UNITED STATES PATENT AND TRADEMARK OFFICE

APPLICATION NO.	FILING DATE	FIRST NAMED INVENTOR	ATTORNEY DOCKET NO.	CONFIRMATION NO.
10/627,623	07/28/2003	Reuven Unger	P23593	4331
7055 7590 10/22/2007 GREENBLUM & BERNSTEIN, P.L.C. 1950 ROLAND CLARKE PLACE RESTON, VA 20191			EXAMINER GARCIA, ERNESTO	
			ART UNIT 3679	PAPER NUMBER
			NOTIFICATION DATE 10/22/2007	DELIVERY MODE ELECTRONIC

Office Action Summary

DETAILED ACTION

Bauer, 3,648,999

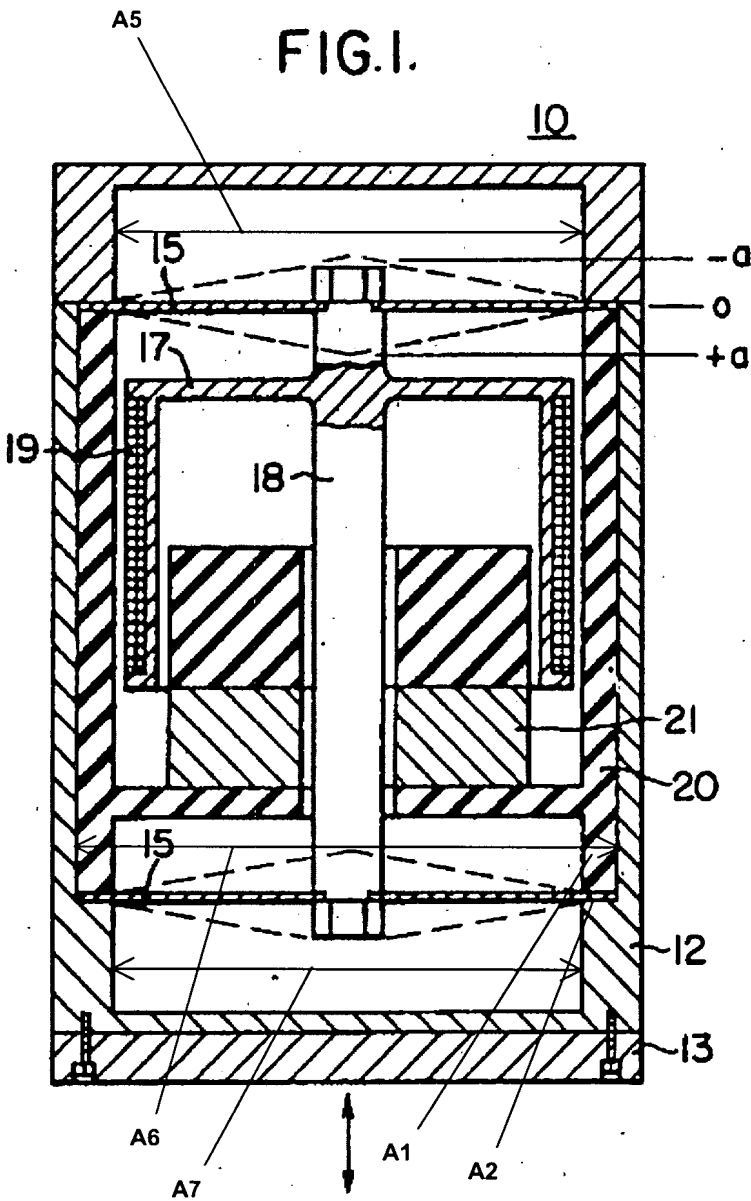
Regarding claim 1, Bauer discloses, in Figure 1, a securing device comprising a spring **15**, a rod **18**, a generally annular spring support **12** and a generally annular coupling ring **A1** (see marked-up attachment). The spring **15** supports the rod **18** at a central portion of the spring and biases the rod **18**. The spring support **12** includes a spring mount **A2** projecting in an inner side of the spring support **12**. An outer peripheral portion of the spring **15** is prevented from movement by the spring support **12** and the coupling ring. The spring support **12** has a first inner diameter **A5** (see marked-up attachment), a second inner diameter **A6**, and a third inner diameter **A7** in this order. The third inner diameter **A7** is smaller than the second inner diameter **A6**. The spring mount **A2** is positioned at a region of the spring support **12** located between the second inner diameter **A6** and the third inner diameter **A7**.

Regarding claim 26, the spring support **12** and the coupling ring **A1** clamp the outer peripheral portion of the spring **15** therebetween.

Regarding claim 30, the spring **15** is secured to the rod **18**.

With respect to Bauer, applicant argues that Bauer discloses two inner diameters, and that the Examiner's identified "third" inner diameter A7 is the same as the first diameter A5. In response, it should be noted that the spring mount is the entire

housing which includes three inner diameters as a whole. With respect to inner diameter A7 being the same as the first diameter A5, it should be noted that the claim does not establish that the first and third diameter have to be different in size. The claim merely establishes that the third diameter is smaller than the second diameter and nothing else.

Fig. 1.

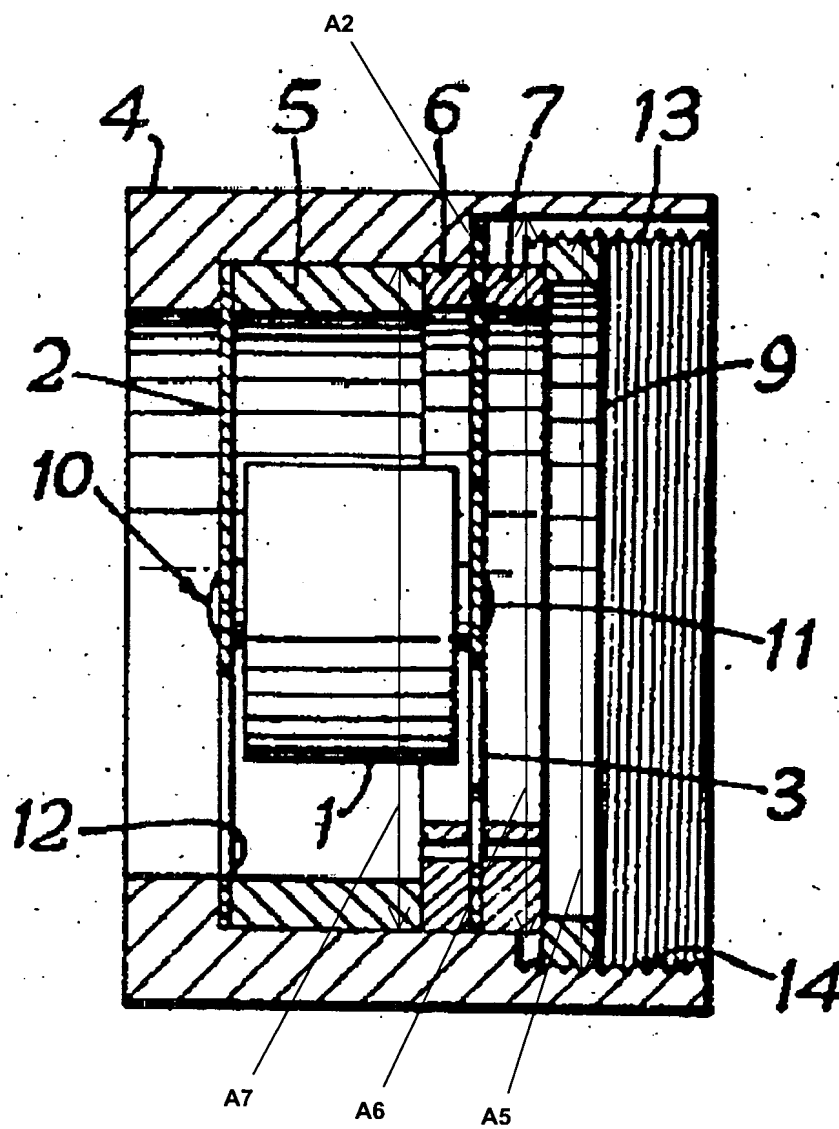
Regarding claim 1, Phillips et al. disclose, in Figure 1, a securing device comprising a spring **3**, a rod **1**, a generally annular spring support **4** and a generally annular coupling ring **9**. The spring **3** supports the rod **1** at a central portion of the spring **3** and biases the rod **1**. The spring support **4** includes a spring mount **A2** (see marked-up attachment) projecting in an inner side of the spring support **4**. An outer peripheral portion of the spring **3** is prevented from movement by the spring support **4** and the coupling ring **9**. The spring support **4** has a first inner diameter **A5** (see marked-up attachment), a second inner diameter **A6**, and a third inner diameter **A7** in this order. The third diameter **A7** is smaller than the second inner diameter **A6**. The spring mount **A2** positioned at a region of the spring support **4** located between the second inner diameter **A6** and the third inner diameter **A7**.

Regarding claim 3, a first thread is formed on an inner periphery of a portion of the first inner diameter **A5**, and a second thread is formed on an outer periphery of the coupling ring **9**. The first thread and the second thread threadably engage each other.

Regarding claim 26, the spring support **4** and the coupling ring **9** clamp the outer peripheral portion of the spring **3** therebetween.

Regarding claim 30, the spring **6** is secured to the rod **1**.

Petty, 2,348,225

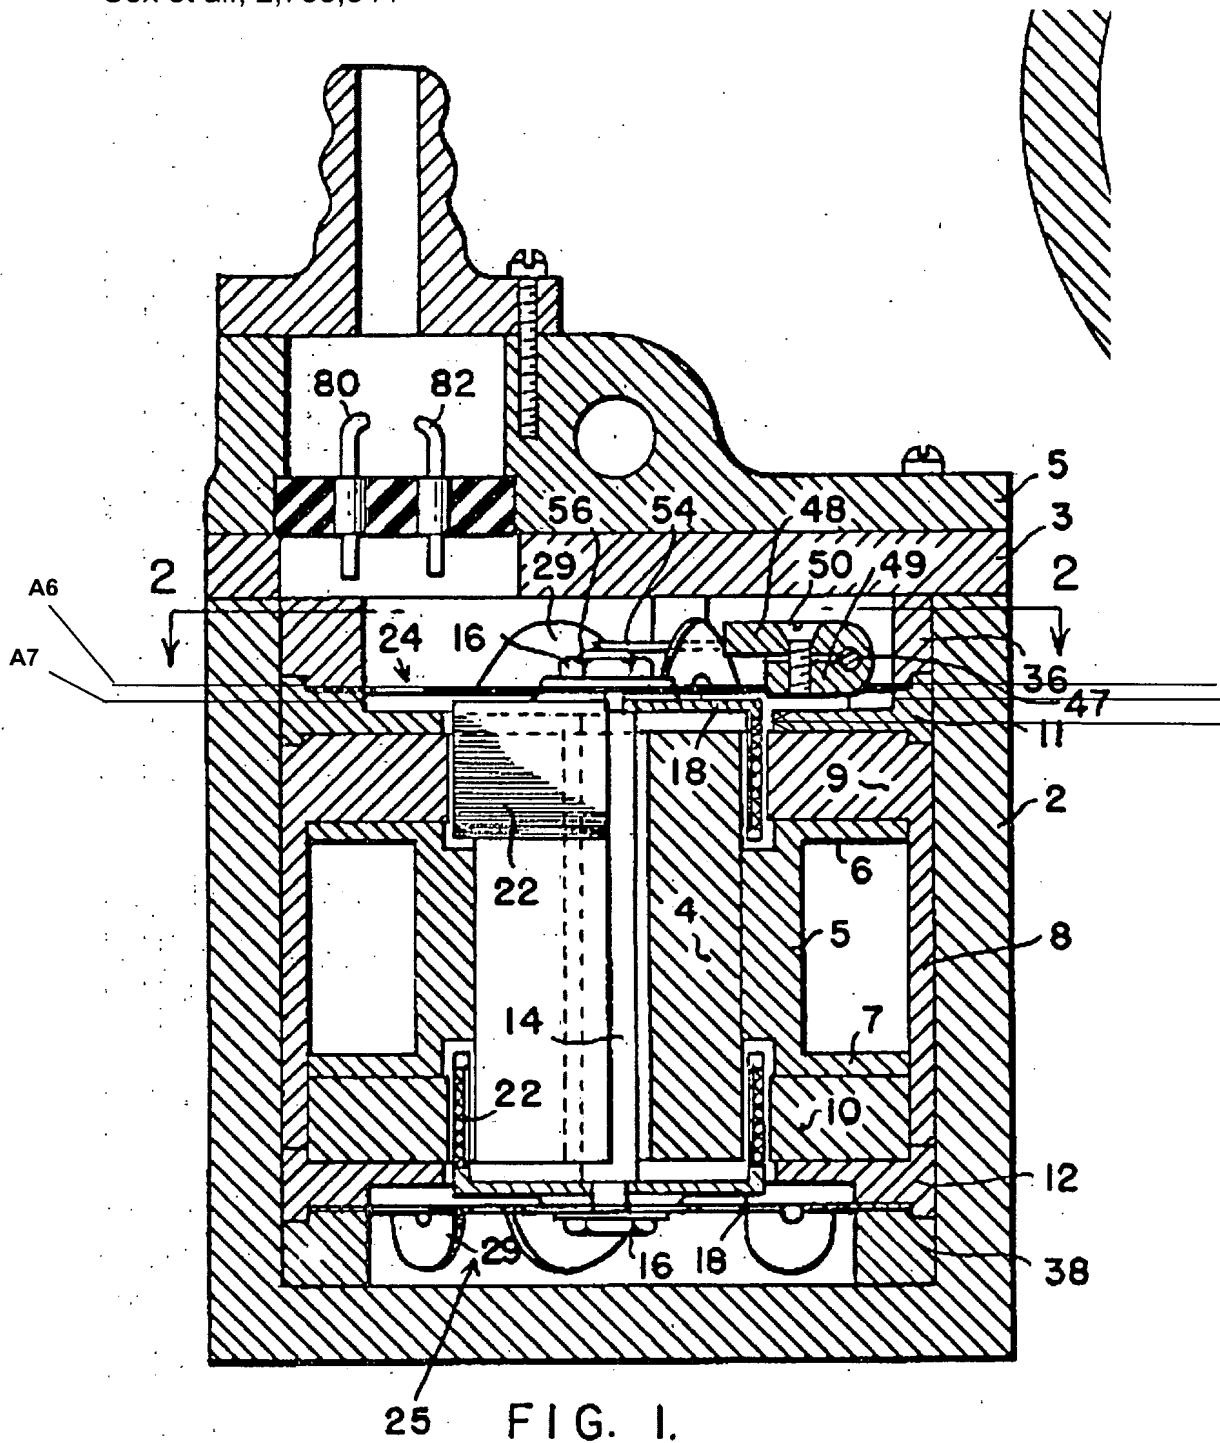
Regarding claim 10, Petty discloses, in Figure 1, a securing device comprising a spring **21**, a rod **27**, a generally annular spring support **10**, and a generally annular coupling ring **31**. The spring support **10** includes a spring mount **30** projecting in an inner side of the spring support **10** and configured to support the spring **21**. The spring support **12** has three inner diameters consisting of, in this order, a first inner diameter **A5**, a second inner diameter **A6**, and a third inner diameter **A7** that is smaller than the second inner diameter **A7**. The spring mount **10** is positioned at a region of the spring support **10** located between the second inner diameter **A5** and the third inner diameter **A7**. Holes **34** are in the coupling ring **31**. However, Petty fails to disclose the holes **34** being threaded. Muellenberg teaches between Figures 1 and 3, holes **29** that are not threaded and holes that are threaded **9** to place withdrawal screws and release a ring in a threaded opening (col. 4, lines 13-17, and col. 5, lines 1-6). Therefore, as taught by Muellenberg, it would have been obvious to one of ordinary skill in the art at the time the invention was made to use threaded holes to place withdrawal screws to release the

Regarding claim 12, a first thread is formed on an inner periphery of a portion of the first inner diameter A5. A second thread is formed on an outer periphery of the coupling ring 31. The first thread and the second thread engage each other.

Regarding claim 14, the threaded holes 34, as modified, are at an interval of approximately 90 degrees or 180 degrees on the coupling ring 31.

Regarding claim 28, the spring support 10 and the coupling ring 31 clamp the outer peripheral portion of the spring 21 therebetween.

Regarding claim 32, the spring 21 is secured to the rod 27.

With respect to Petty, applicant argues that Petty only discloses two inner diameters A5 and A6 and that the examiner identified 'third' inner diameter A7 is that of the Examiner's identified spring mount 30. This is not found persuasive since the spring support is made up of components 10 and 30 together and such contains three diameters as identified. The fact that component 30 is spaced away is moot since Petty discloses at column 4, lines 30-33, the component 30 being close to component 10 thus no clearance will exist. Accordingly, the spring support will contain a spring mount and be positioned between the second diameter and the third diameter. With respect to the argument made to the language "consisting of", note the 35 USC 112, 2nd paragraph rejection.
